Version #2 of Cm #012

AMENDMENT OF SOLICITATION/MODIFICATION OF CONTRACT		1. CONTRACT ID CODE	PAGE 1 OF 4 PAGES
2. AMENDMENT/MODIFICATION NO. Contract Modification No. 012	3. EFFECTIVE DATE See Block 16c	4. REQUISITION/PURCHASE REQ. NO.	5. PROJECT NO. (If applicable) North Bend Road OR PFH 97-1(8)
6. ISSUED BY CODE Western Federal Lands Highway Division 610 East Fifth Street Vancouver, WA 98661	7. ADMINISTERED BY (If other than Item 6) CODE		
8. NAME AND ADDRESS OF CONTRACTOR (No., street, county, State and ZIP Code) Buildmore Johnson, Inc. P.O. Box 2361 Heppner, OR 94201		(✓) 9A. AMENDMENT OF SOLICITATION NO.	
		9B. DATED (SEE ITEM 11)	
		10A. MODIFICATION OF CONTRACT/ORDER NO. DTFH70-09-C-00007	
		10B. DATED (SEE ITEM 13) January 14, 2009	
CODE	FACILITY CODE

This contract modification definitizes Contract Modification #011.

VEE DITCH

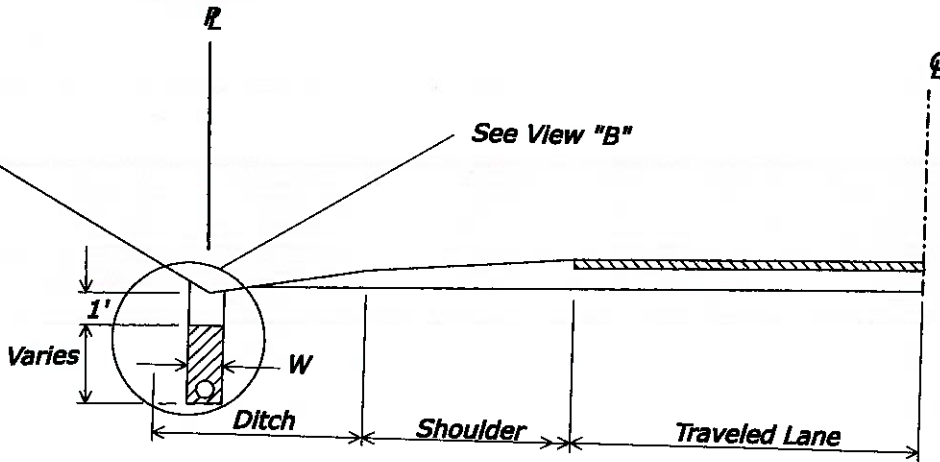
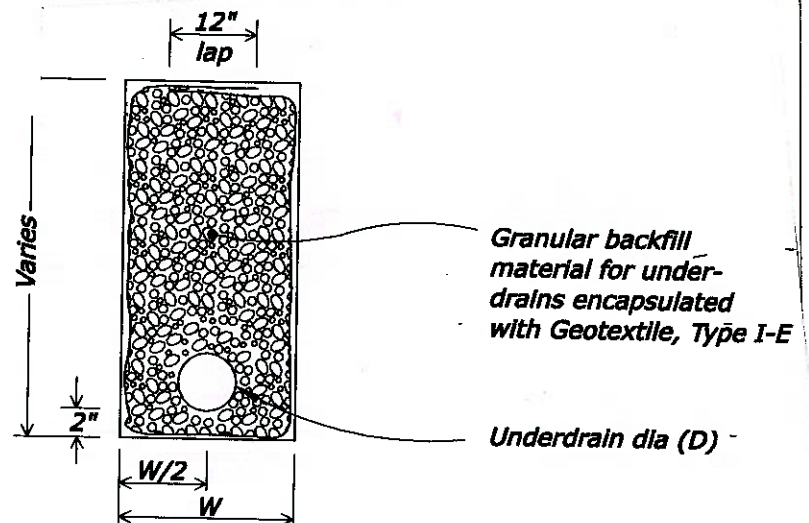
This modification calls for the installation of an underdrain system to handle subsurface water encountered between Sta. 126+50 Lt. and Sta. 131+00 Lt. It also modifies to the culvert inlet at Sta. 128+25 Lt. to accommodate the underdrain outlet pipes.

This work also consists of furnishing and install underdrain systems using pipe, granular backfill, permeable backfill and geotextile.

1. Location of pipe underdrains may be adjusted by the CO.
2. Minimum underdrain grade is 0.5 percent.

DIAMETER (D)	MINIMUM WIDTH (W)
6"	15"
